Staff Report

Petition 12249

VERMONT, Section 2

STEVEN N AND JAN COWAN

See amended proposed zoning map below vs. original proposal at bottom:

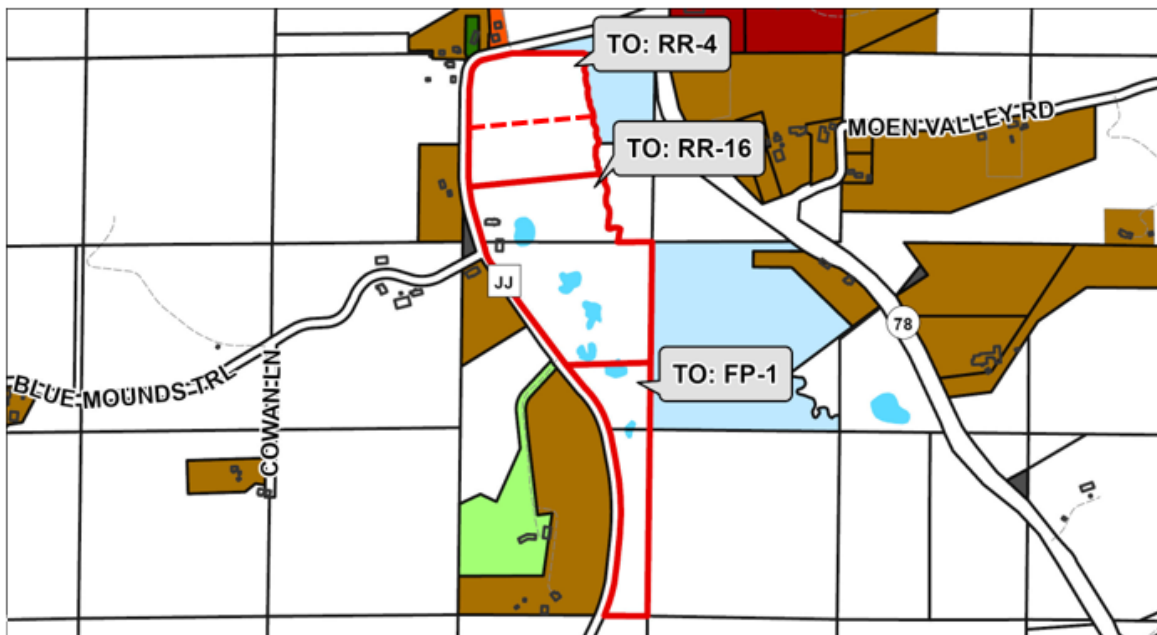
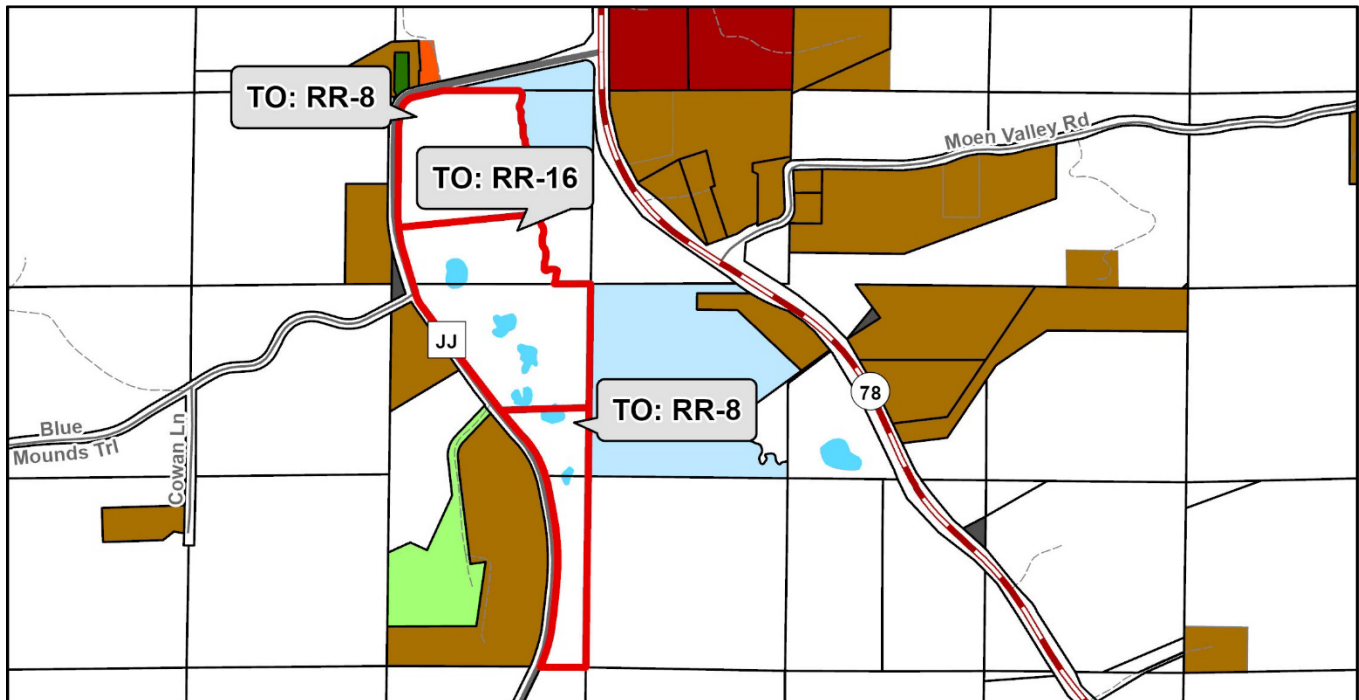
FP-35 Farmland Preservation District TO RR-8 Rural Residential District AND RR-16 Rural Residential District

creating ~~one agricultural lot and~~ 3 residential lots (one for existing residence)

DESCRIPTION: The Cowans propose a rezoning in order to create three residential lots and one agricultural lot with a 4-lot certified survey map (CSM). Two new residential lots would be zoned RR-4, one lot would be zoned RR-16 and contain the existing farmstead, and the fourth lot would contain the remaining ag land with FP-1 zoning. [Note: The proposal has been amended, to propose a 3-lot CSM with RR-8, RR-16, and RR-8 zoning, and no agricultural lot. The lot numbers referenced herein reflect the original 4-lot CSM, to match other documents provided by the applicants.]

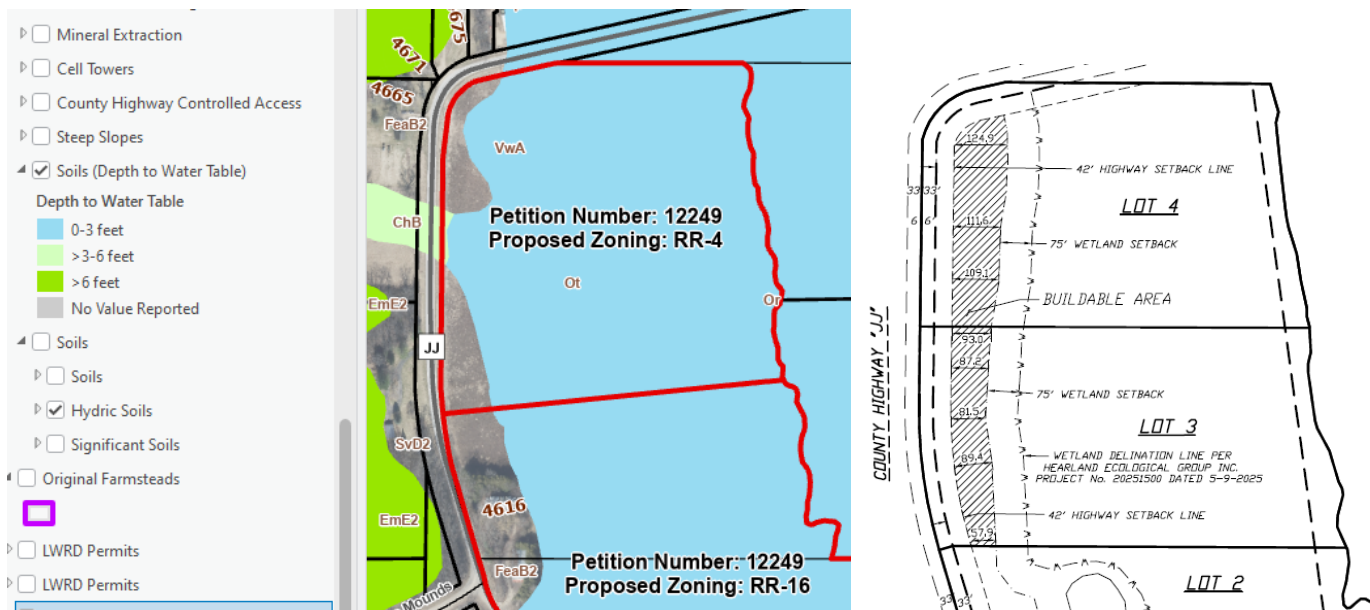
RESOURCE PROTECTION: The majority of land included within this petition is within a resource protection area containing environmentally sensitive features including Vermont Creek which flows from south to north forming the eastern property boundary. Lands adjacent to this property is owned and managed by the Wisconsin Department of Natural Resources as the Black Earth Creek East Fishery Area. Vermont Creek is bounded by an expansive Zone A regulatory floodplain. Zone A floodplains are unstudied and therefore do not have a determined base flood elevation. Any development within the mapped floodplain is subject to floodplain development standards. The riparian zone of Vermont Creek also contains an extensive wetland area.

The applicant has provided a wetland delineation which confirms that the required 75-foot wetland setback is the limiting factor for development on this property. While the property contains shoreland and floodplain zoning, the wetland zoning establishes that only a small narrow building envelope exists on the west site of the property.

Although development would not be permitted within the shoreland or floodplain portion of the property due to the required wetland setback, Staff still has concerns with the developability of the proposed lots.

- The relatively small, and narrow, building envelopes compared to the proposed lot size will constrain development. While the building envelopes take advantage of the slight upland portion of the land, the grades are slight and the entire property has a shallow depth to groundwater due to the proximity of the wetlands.
- The applicant has not provided any information on soil suitability for septic systems. While structures must adhere to the 75-foot wetland setback, a septic system is permitted to be within the setback, but not within the mapped wetland.
- In addition to a soil test being needed to understand how sewage treatment will be handled, it can be useful to help establish a minimum basement elevation for new homes on Lots 3 and 4.

The proposed building envelopes are outside of the shoreland zone (beyond 300 feet from Vermont Creek) and therefore will not be regulated for impervious surface limits. Regardless of proximity, it is important to note that all impervious surfaces will drain directly to the resource. This could result in modification of existing drainage patterns that impact the wetland and shoreland resource.

The information provided verifies the proposed lots can have homes built and can be served by septic systems. Staff recommends approval of rezone petition 12249 with the following conditions:

1. The lowest floor elevation shall be at or above 834 feet above average sea level (based on the SES Geotechnical Report dated 6/23/2026).
